# WETLANDS NOTICE OF INTENT

## PROPOSED WORKSHOP BUILDING

Precourt Stone  
46 Union Avenue  
Sudbury, MA 01776

The Horsley Witten Group, Inc. (HW) is pleased to provide the Sudbury Planning Board with this letter report summarizing our second review of the proposed development at 44 & 46 Union Avenue. The Project Area includes the Precourt Stone facility office and storage yard, a property owned by the Union Avenue Realty, LLC. The Precourt Stone property covers approximately 5.75 acres over 3 separate parcels. Approximately 0.88 acres comprises the “rear” parcel, a material storage yard where the work is being proposed.

**STABILIZED CONSTRUCTION ENTRANCE DETAIL**

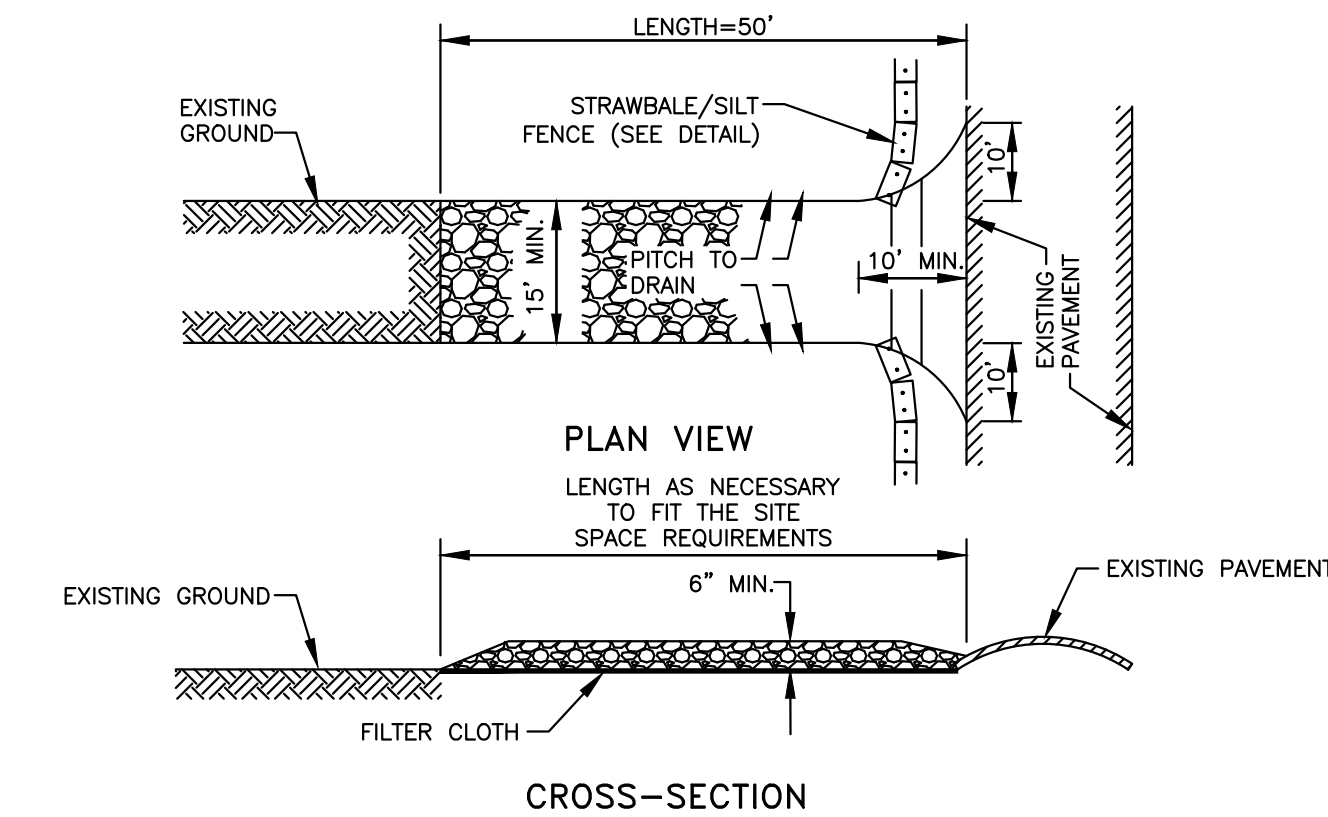
- d. The Applicant has noted a construction entrance at the west side of the site but has not indicated any dimensions. The detail noted does not provide any minimum dimensions for the entrance. HW recommends providing the applicable dimensions.

**The Applicant has provided the applicable dimensions as requested. No further comment.**
